Service Info

Claas / Renault** - 228 0027 14 - 280/280 TGU6

New design / Neues Design / Nouvelle conception / Nuevo diseño / Nuovo disegno

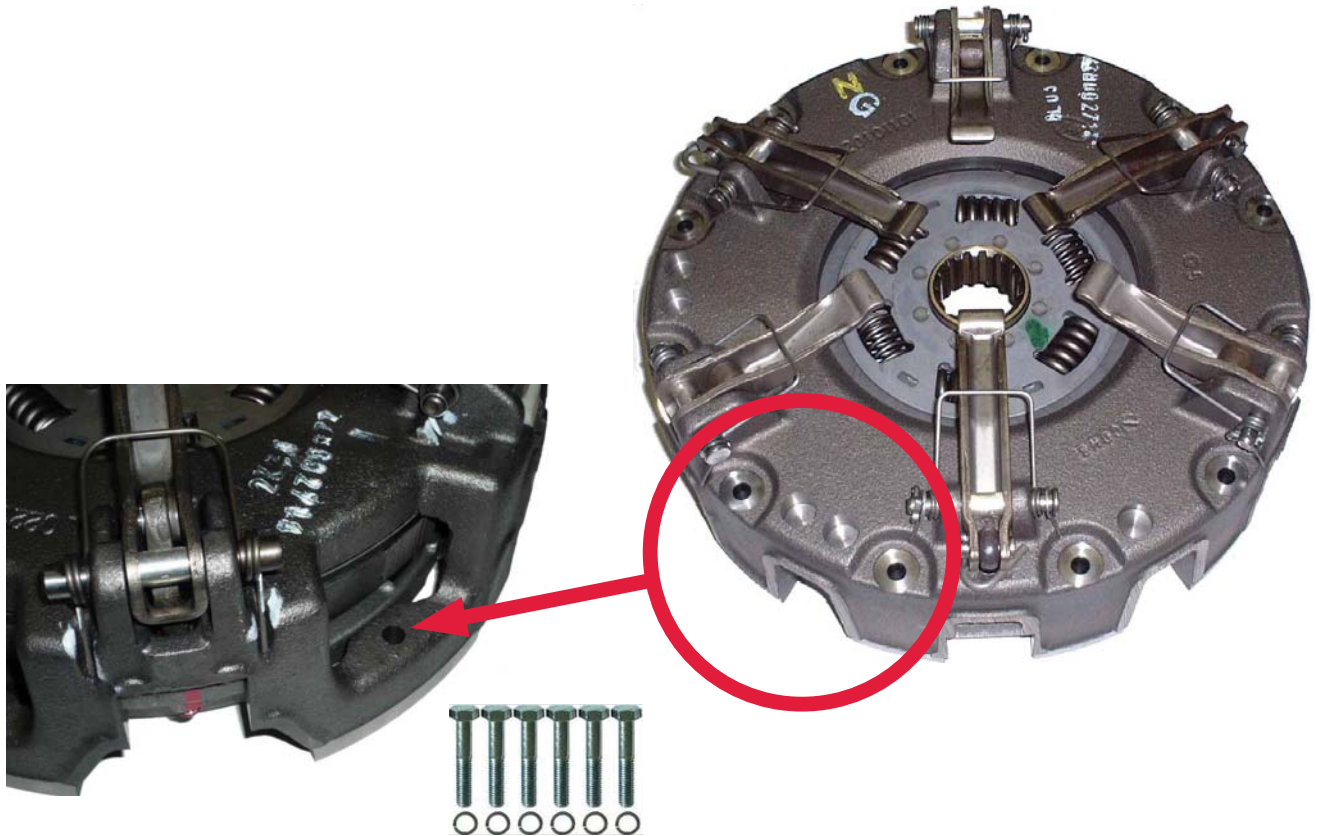
This new design utilises the latest clutch technology, using a vented housing for improved cooling and heat dispersal.

**Fully interchangeable with existing clutches with no modifications required to vehicle or flywheel.
New fixation bolt set 6 x M8 x 1.25 x 50mm is supplied with new designs to accommodate the lower housing.**
